PLANNING AND ZONING COMMISSION MEETING

City Council Chambers, 33 East Broadway Avenue Meridian, Idaho
Thursday, April 28, 2022 at 6:00 PM

Agenda

B. Preliminary Plat (dated: March 18, 2022)

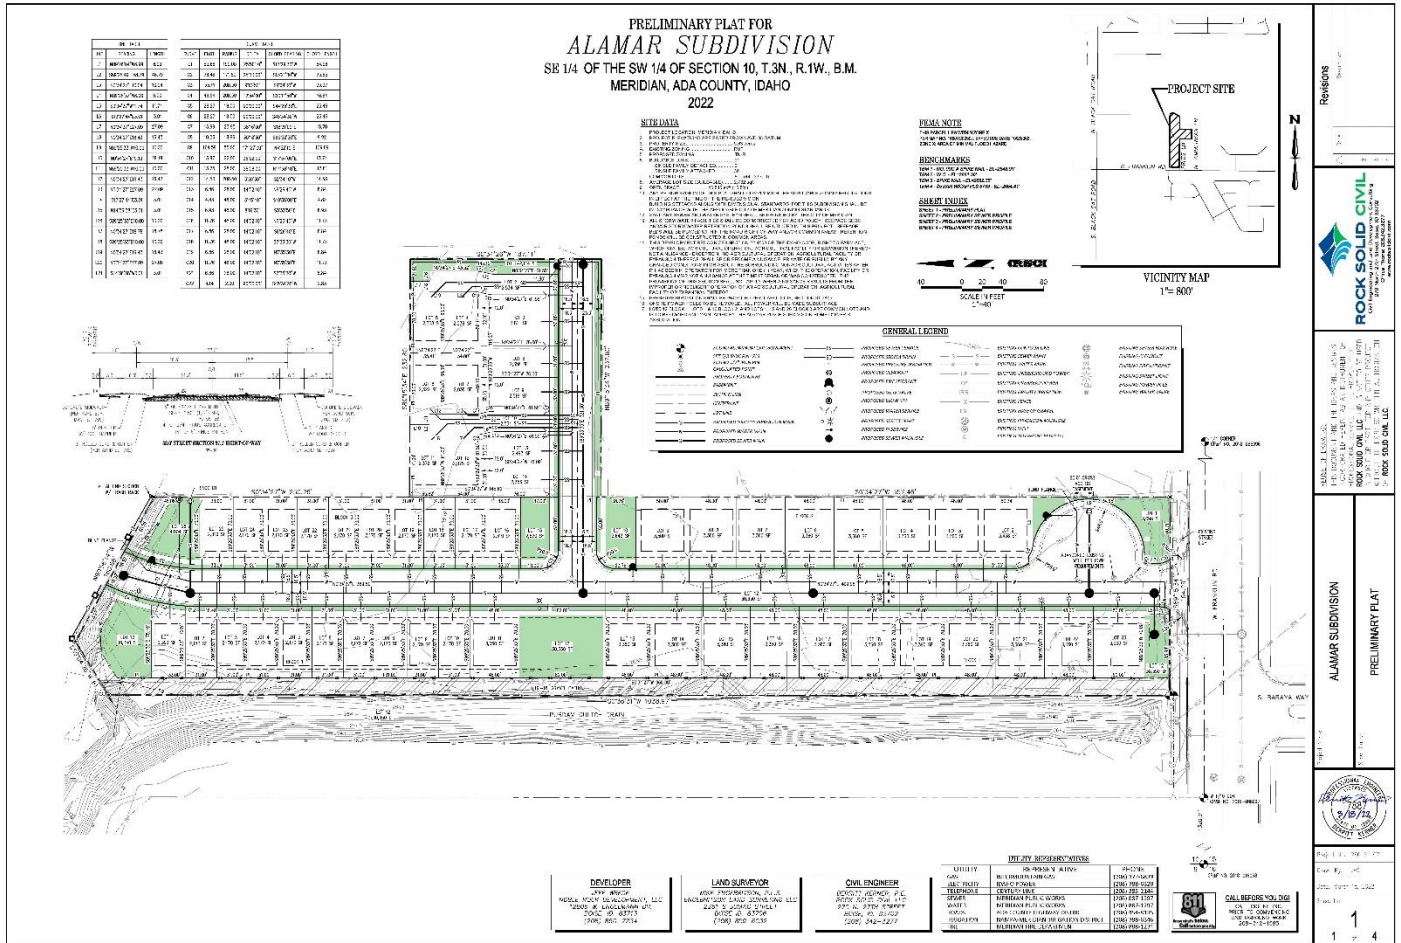
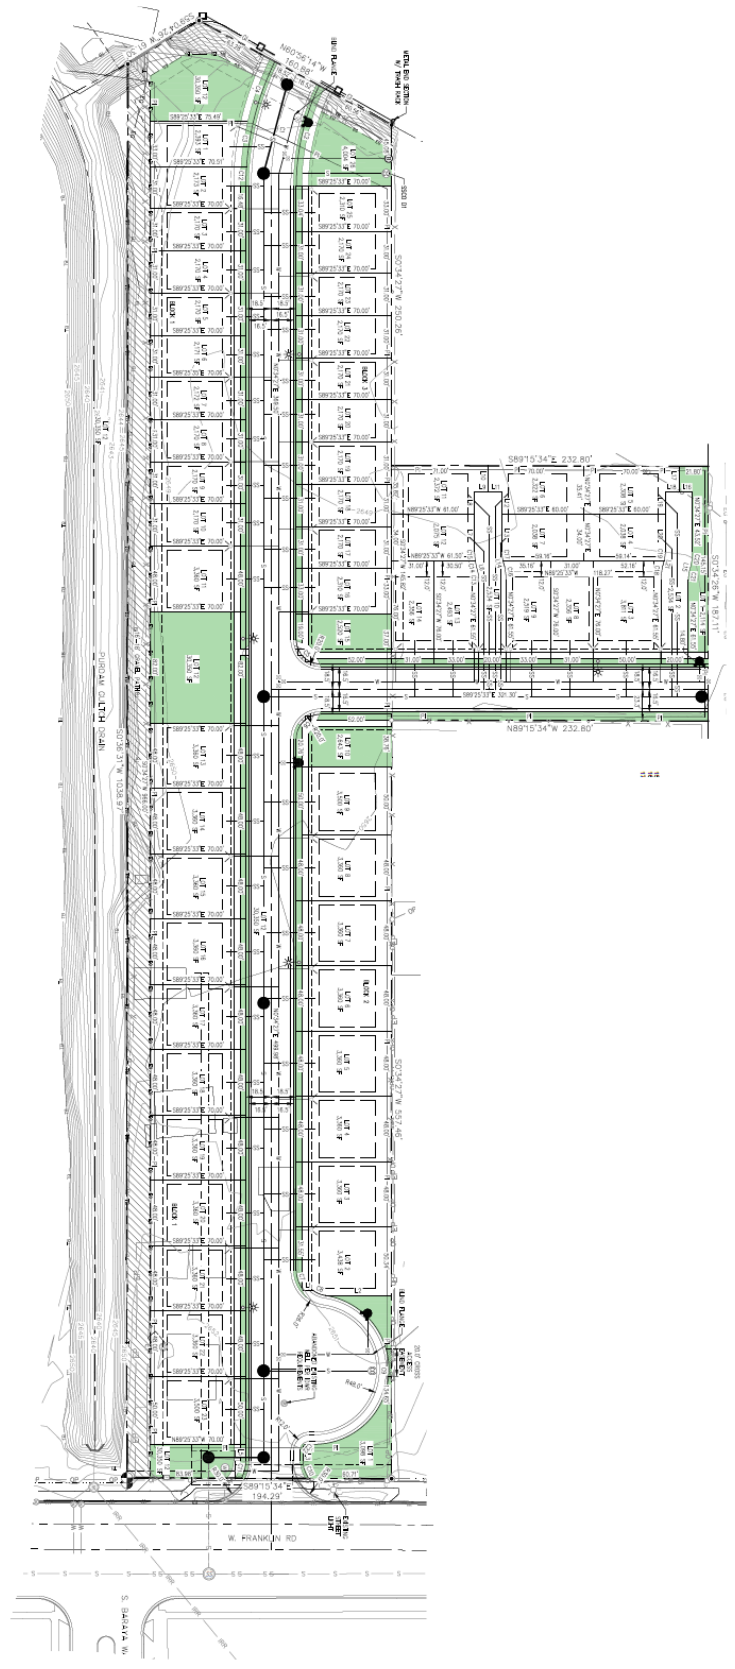
An open space exhibit was not submitted with the applications but it appears the Applicant has proposed approximately 32,500 square feet of qualified open space; this area does not meet the minimum 15% requirement which amounts to at least 36,700 square feet. However, if the Applicant is able to obtain irrigation district approval and provide a pathway along the west boundary and

Based on the plat area of 5.63 acres, the minimum amount of qualified open space required to meet UDC 11-3G-3 standards is approximately 36,786 square feet. According to Staff's analysis of the submitted plans, the Applicant is proposing approximately 32,500 square feet of qualified open space; this area does not meet the minimum 15% requirement. This includes the proposed parkways, arterial street buffer to Franklin, the central open space lot (portion of Lot 12, Block 1), and other smaller areas of open space throughout the site. As discussed throughout this report, there is potential of the entire Lot 12, Block 1 counting towards the qualified open space if additional pedestrian facilities are added to this lot. Specifically, Staff recommends adding a 5-foot wide micro-path from the detached sidewalk along the local street in two locations; within the central open space lot and in the open space area in the northwest corner of the site. Further, additional pedestrian facilities would need to be added to this lot within the drain easement area to create a looped system for the project. These cumulative revisions are required in order for this easement area of Lot 12 to count towards the qualified open space. If these revisions cannot occur, the Applicant will need to add approximately 4,300 square feet of additional qualified open space in the project—because of the site design, this would likely require the loss of building lots.

8. The submitted preliminary plat, dated March 15, 2022, shall be revised as follows with the first final plat submittal:
 - a. Revise the plat to include the required revisions to meet the minimum open space requirements as outlined in Condition VIII.A.2 above.

B. Preliminary Plat (dated: 2/3/2022) (NOT APPROVED)

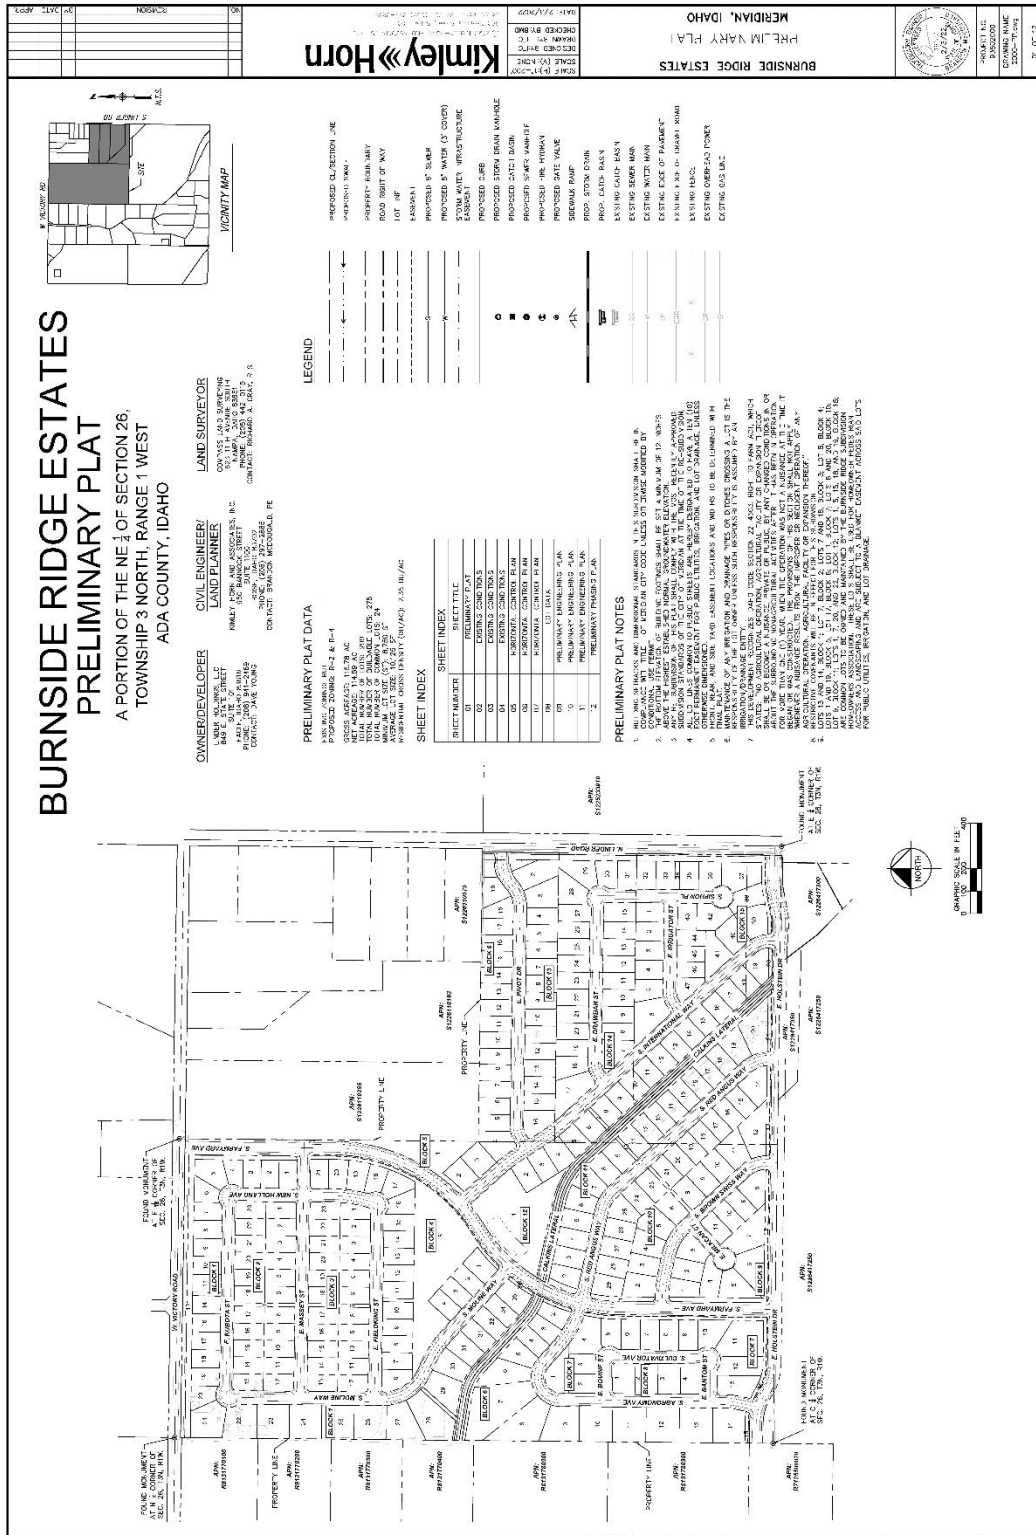
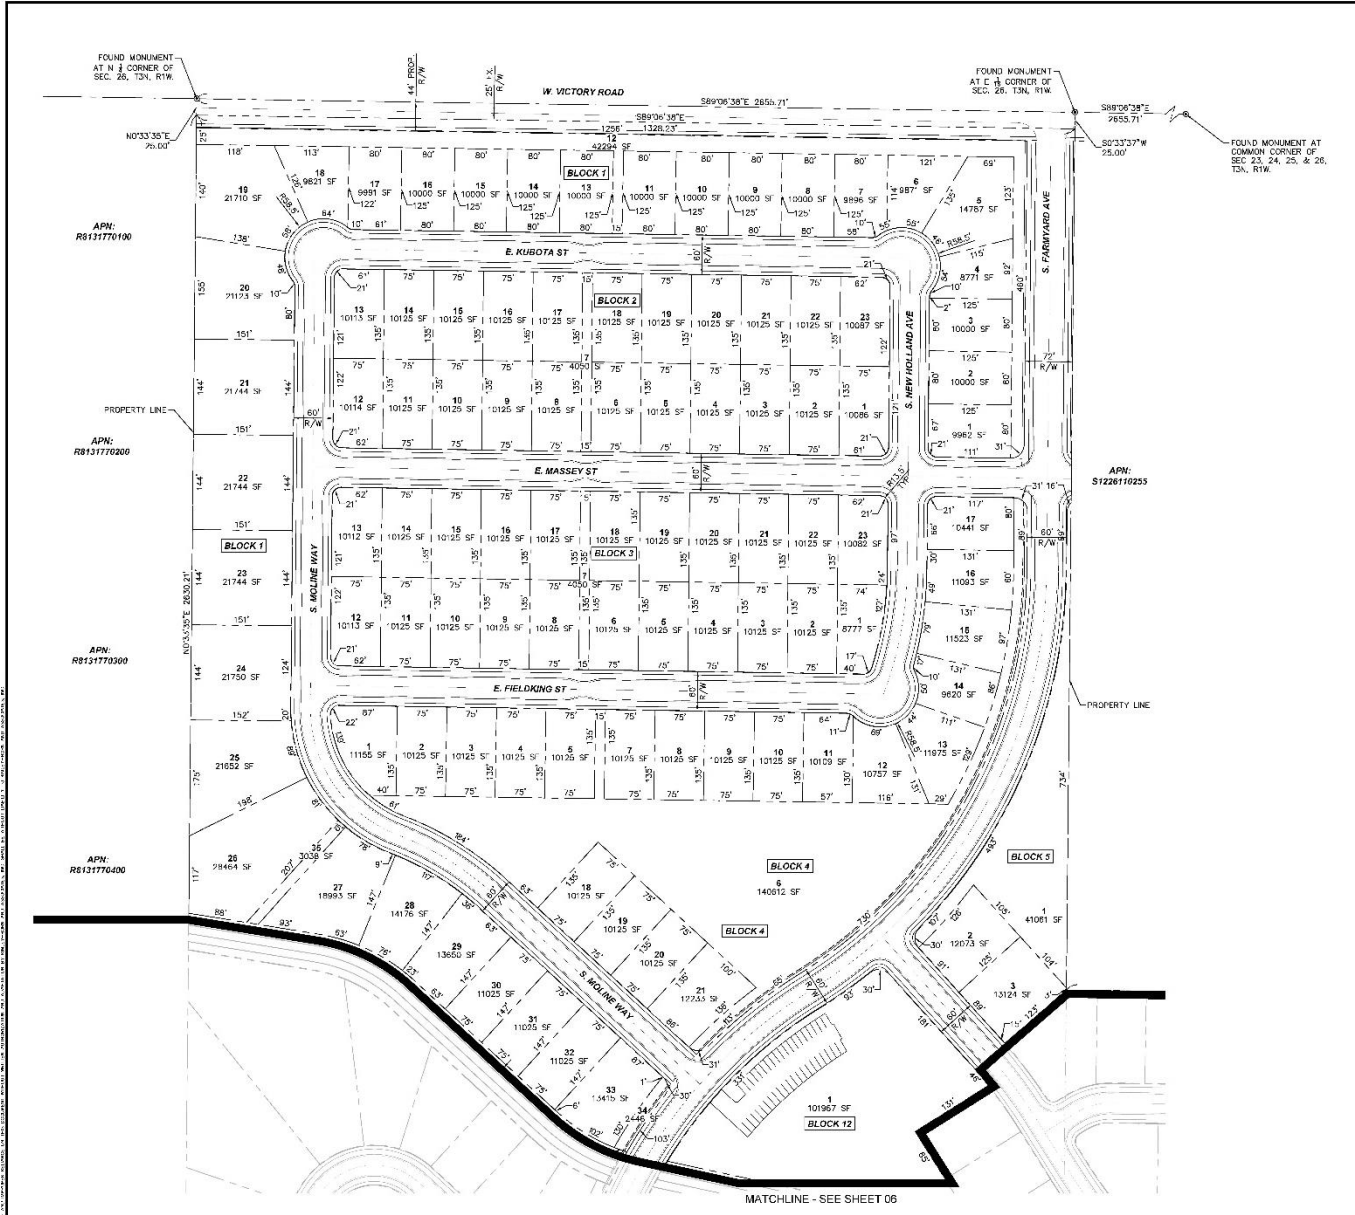
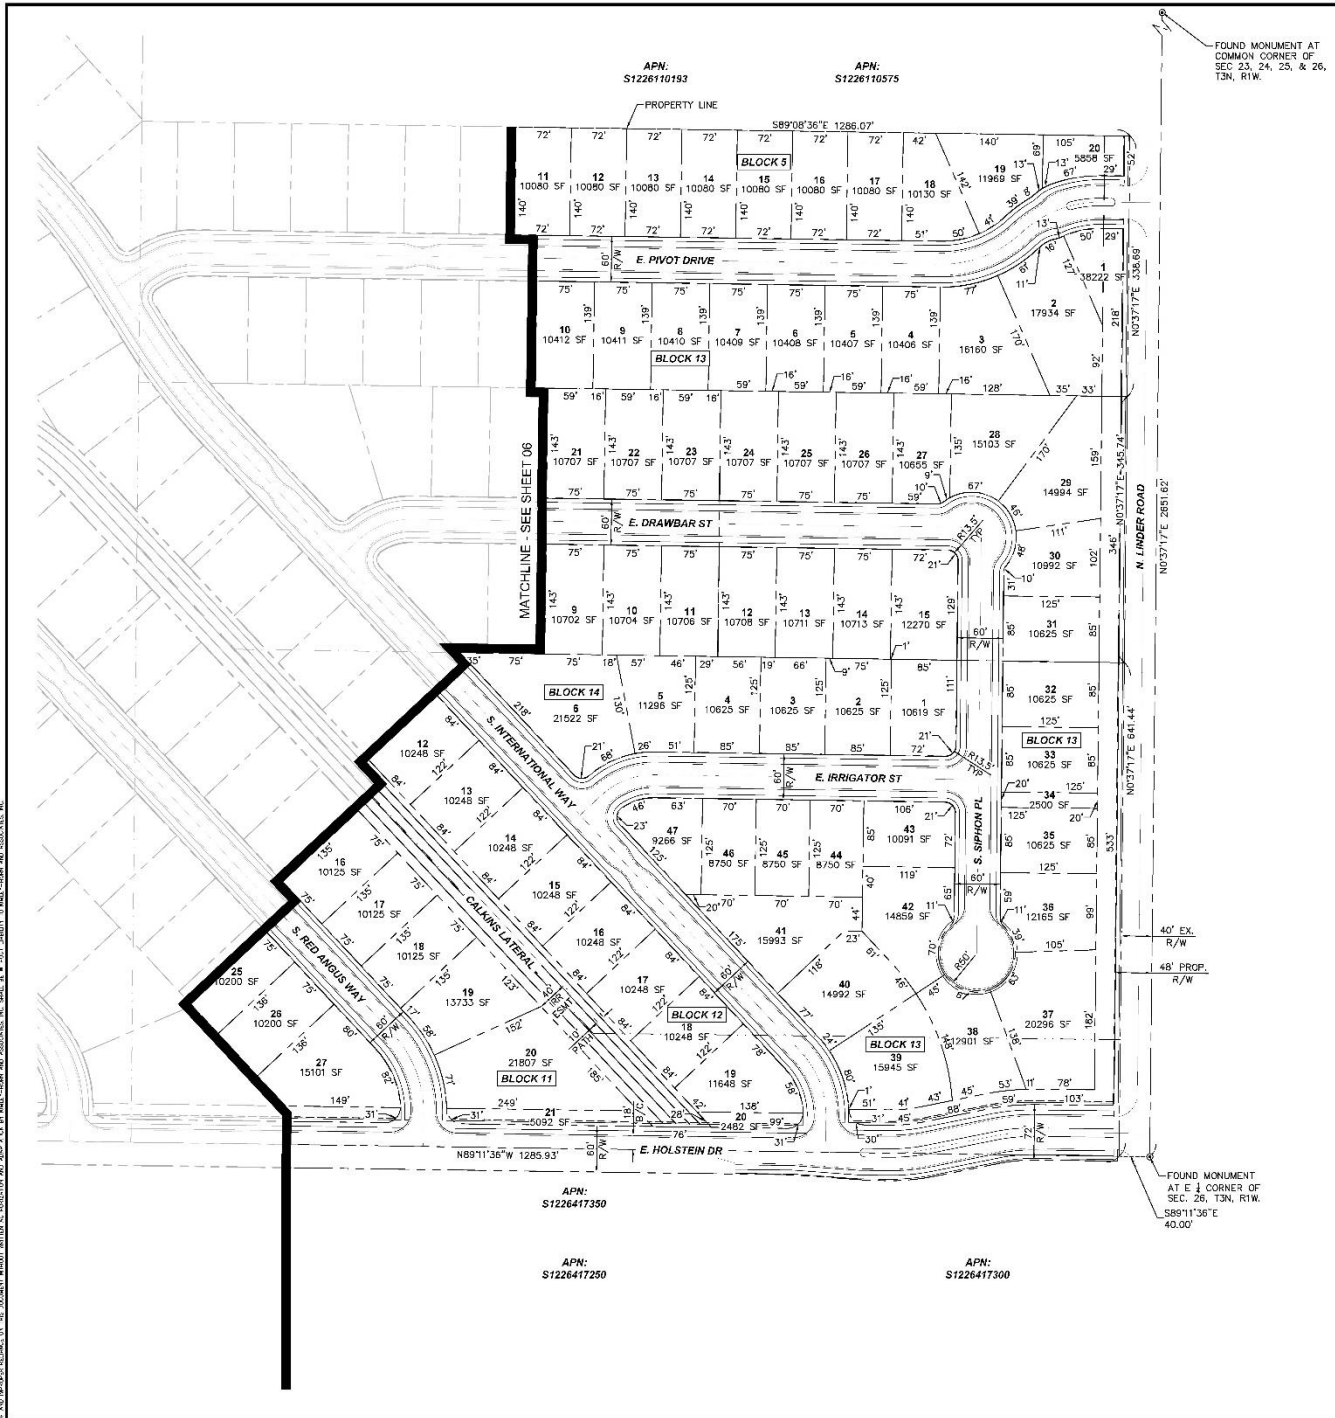
Based on this policy, the LDR designation can be “floated” beyond the area depicted on the future land use map up to the east side of the north-south collector street proposed with this development (S. Farnyard Avenue). Subsequently, the gross density west of S. Farnyard must meet the minimum gross density for the MDR designation (at least 3 du/ac.). Additionally, the plan allows gross densities to be rounded up or down, therefore the minimum gross density of this area must be at least 2.5 du/ac. According to the submitted plans, the area west of the proposed collector is approximately 54 acres and contains 126 units which is approximately 2.33 du/ac and does not meet the minimum gross density of the MDR designation. Therefore, the Applicant should add at least 9 additional building lots to meet the minimum density requirement. If the Applicant does not wish to increase the number of lots, then a Comprehensive Plan Map Amendment is required and this project should be delayed to allow

the applicant to submit a concurrent CPAM application which could be processed no earlier than June 15th. The Applicant is proposing larger lots throughout the development (minimum lot size of 9,900 square feet in this area of the plat) so Staff believes there may be ample area west of the proposed collector to add these additional building lots. However, to increase the number of lots in this area it would require the applicant to amend their annexation request to incorporate an R-8 zoning district due to differing dimensional standards from the R-4 district. Staff recommends the applicant include an area of R-8 zoning in the north area of the plat (Blocks 2 & 3) to allow for some lot sizes smaller than R-4 dimensional standards. Fifteen (15) days prior to the City council hearing the applicant should submit an amended annexation legal description and exhibit map to incorporate R-8 zoning as recommended by staff.
